# Comments for P802.1Qdq

Jie Xiao, Min Zha, Li Xu  
{xiaojie23, zhamin, innon.xu}@huawei.com  
Huawei Technology Co., Ltd

Figure Y-3— Traffic pattern in an application's point of view

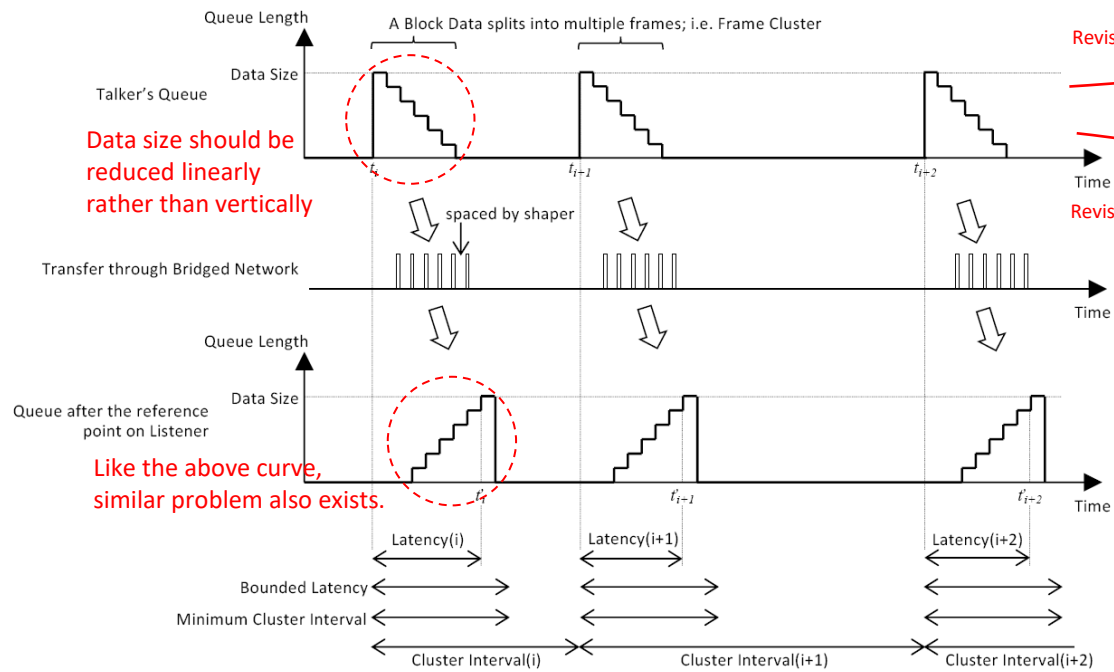
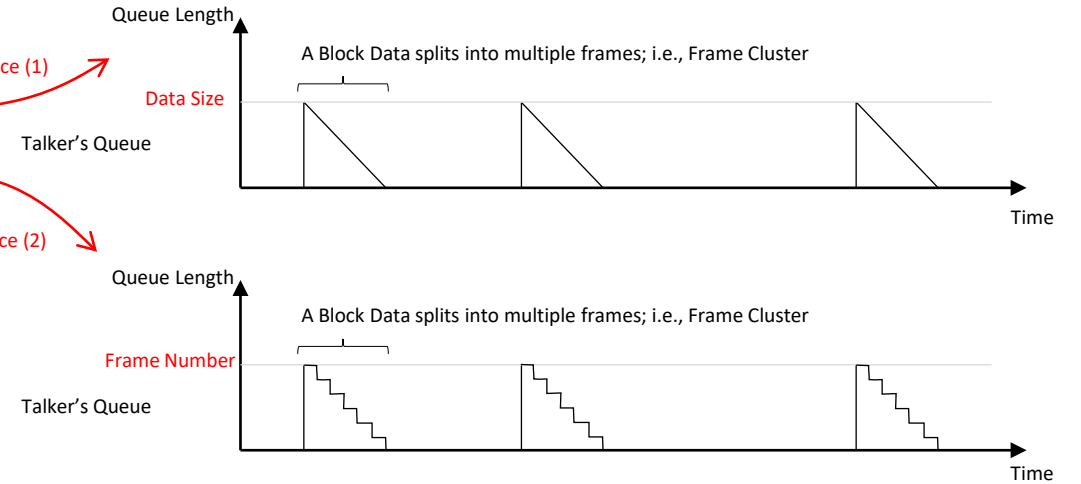
# Comments #1

- Suggested text

Figure Y-4— Frame propagation from Talker to Listener

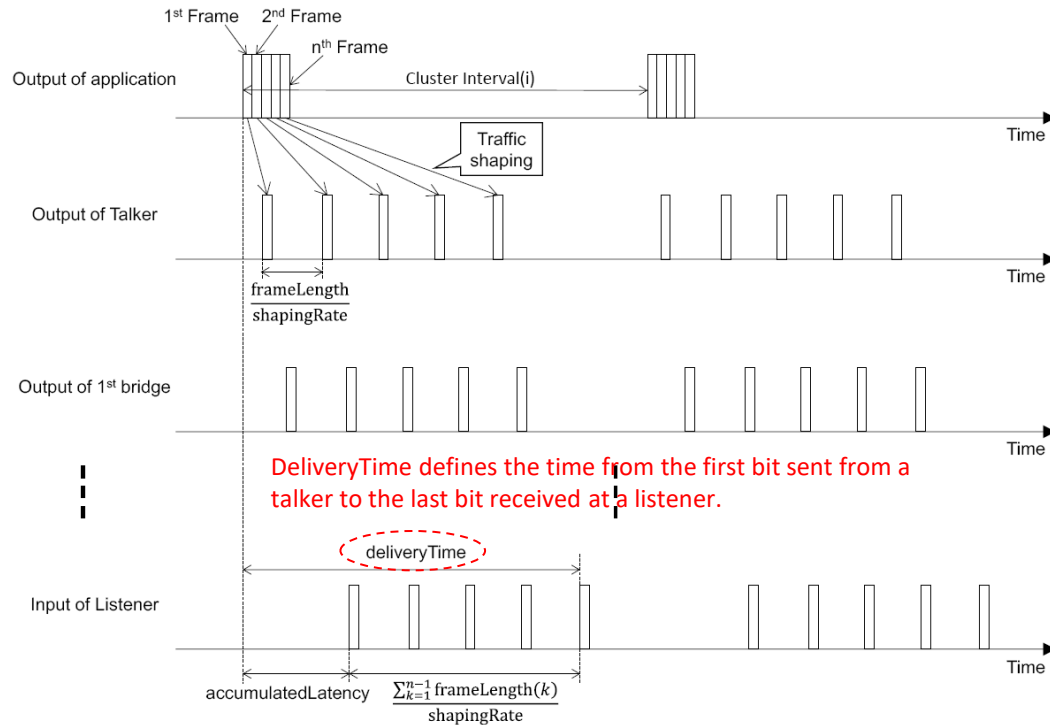
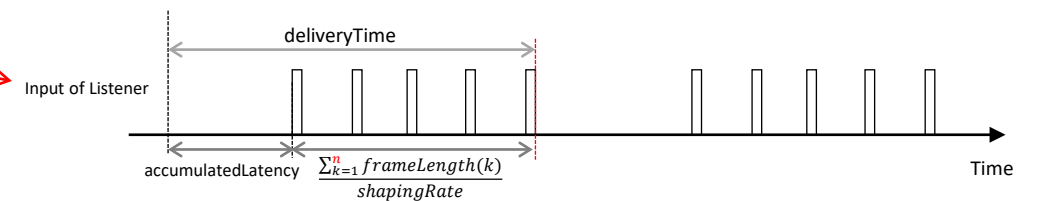
Accordingly, the formulas (Y-2) & (Y-3) should be modified

$$deliveryTime(i) = \frac{\sum_{k=1}^{n-1} frameLength(n)}{shapingRate} + accumulatedLatency \quad (Y-2)$$

$$requiredMinimumShapingRate = \frac{\sum_{k=1}^{n-1} frameLength(k)}{targetLatency} \quad (Y-3)$$

$$= \frac{dataSize - frameLength(n)}{targetLatency}$$

$$deliveryTime(i) = \frac{\sum_{k=1}^n frameLength(k)}{shapingRate} + accumulatedLatency \quad (Y-2)$$

$$requiredMinimumShapingRate = \frac{\sum_{k=1}^n frameLength(k)}{targetLatency} = \frac{dataSize}{targetLatency} \quad (Y-3)$$

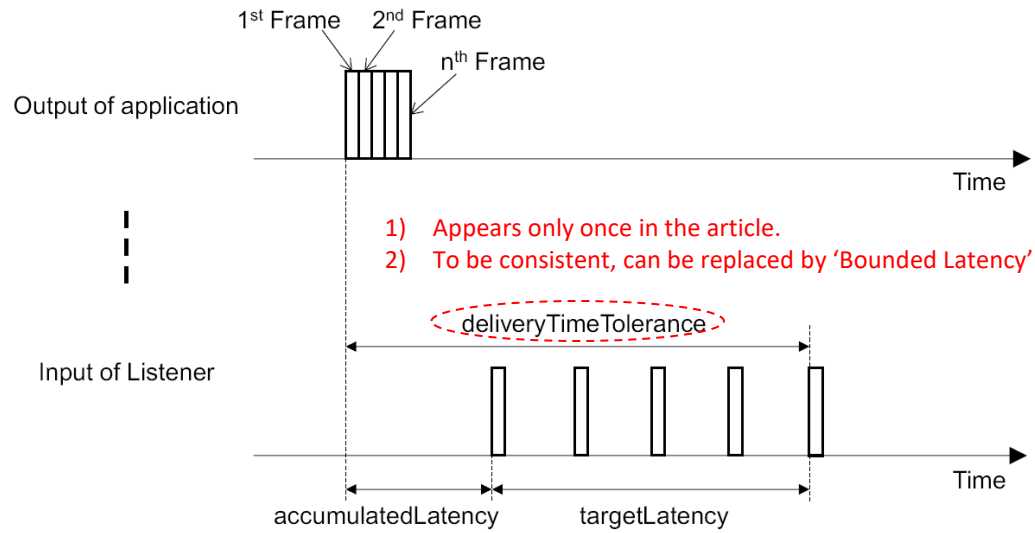
A formula can be added to expressed the calculation more clearly, such that formulas (Y-2) and (Y-3) can move forward more smoothly.

$$\text{targetLatency} = \text{boundedLatency} - \text{accumulatedLatency}$$

Figure Y-5— Frame propagation within bounded latency while minimizing over-provision of bandwidth reservation

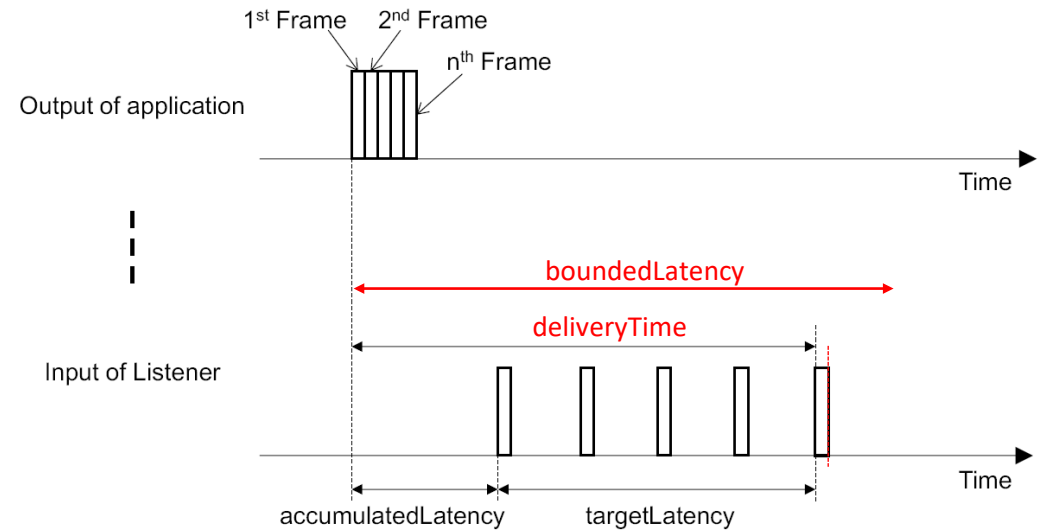
- 1) Appears only once in the article.
- 2) To be consistent, can be replaced by 'Bounded Latency'

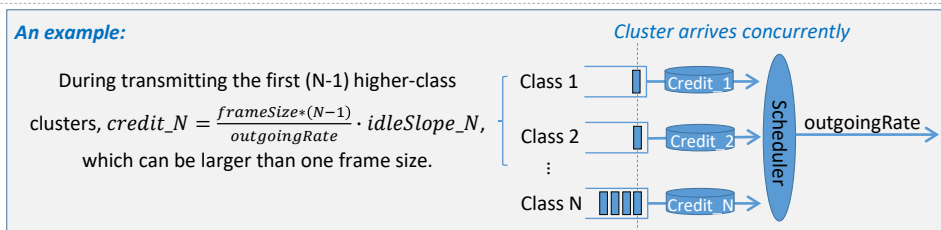
<< Contributor's Note: The ATS scheduler should also works for the case in which the CommittedBurstSize is greater than Maximum SDU Size. It does not affect other traffic for which the long-term averaged shaping rate. However, a small value of the CommittedBurstSize is desirable because the transient data rate, which is higher than the required minimum shaping rate, may be suppressed. This transient manner can be caused by the arrival of a new frame cluster at the shaper that has already accumulated large number of tokens causing some frames to be forwarded instantly. Such token-bucket state can occur when no frames arrive at the shaper for a period of time between clusters. >>

This part should be added and emphasized in the text.

The ATS scheduler should also works for the case in which the CommittedBurstSize is greater than Maximum SDU Size. It does not affect other traffic for which the long-term averaged shaping rate. However, a small value of the CommittedBurstSize is desirable because the transient data rate, which is higher than the required minimum shaping rate, may be suppressed. This transient manner can be caused by the arrival of a new frame cluster at the shaper that has already accumulated large number of tokens causing some frames to be forwarded instantly. Such token-bucket state can occur when no frames arrive at the shaper for a period of time between clusters.

Similar issue also exists in the CBS scheduler. For example, when there are N classes of frame clusters arrive concurrently in the system, during the scheduling of the higher-class clusters, credits of the lowest-class cluster will be accumulated, which may results in consistent transmission of its frames. To alleviate this issue, we should also limit the credit upper-bound to the maximum SDU size.
